# **BUILDING CODE ACTION COMMITTEE MEETING IRC GENERAL WORK GROUP**

**APRIL 11-12, 2019 MEETING**

**GROUP B 2019**

# EB63-19 Part I

#### Note #1

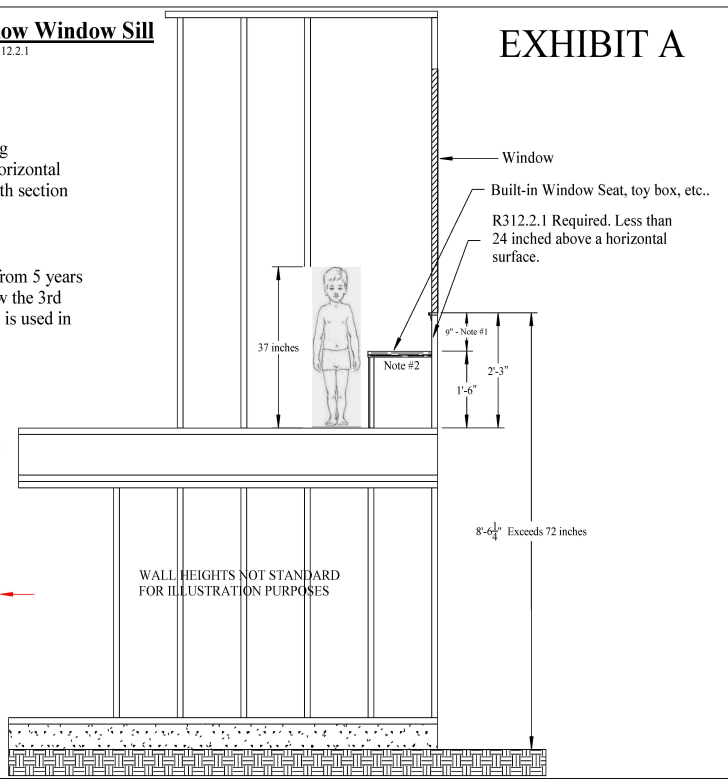
PROPOSED CHANGE: Added text to R312.2.1  
 Author: Norman Clark, CBO

Lowest edge of window opening is less than 24 inches above a horizontal surface below. Must comply with section R312.2.1 of the IRC.

The majority of child falls are from 5 years and younger and are from below the 3rd floor. 37 inches for a 4 year old is used in illustration and is to scale.

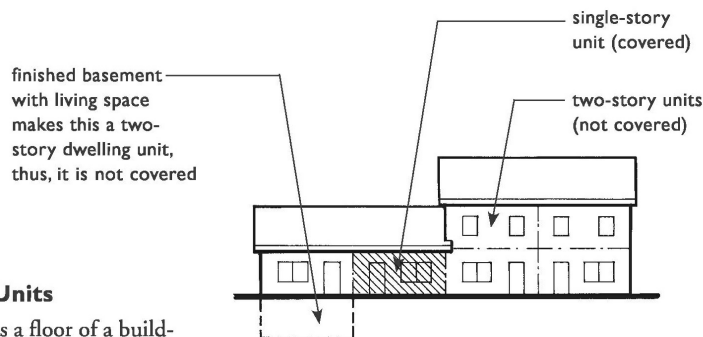
**Reason:** Chapter 11 of the IBC exempts owner-occupied lodging houses with no more than five sleeping units and multistory dwelling units not provided with elevator service. IRC, Section 320 currently only mentions lodging houses being exempt. Therefore, this proposed amendment is intended to clarify, without the designer having to refer to both Section 320 of the IRC and Chapter 11 of the IBC, multistory dwelling units not provided with elevator service are not required to comply.

The following illustration from the Fair Housing Act Design Manual visually depicts which units are "covered" by the act, and which are "not covered." It also depicts the scope of Chapter 11 of the IBC and the intent of this amendment.
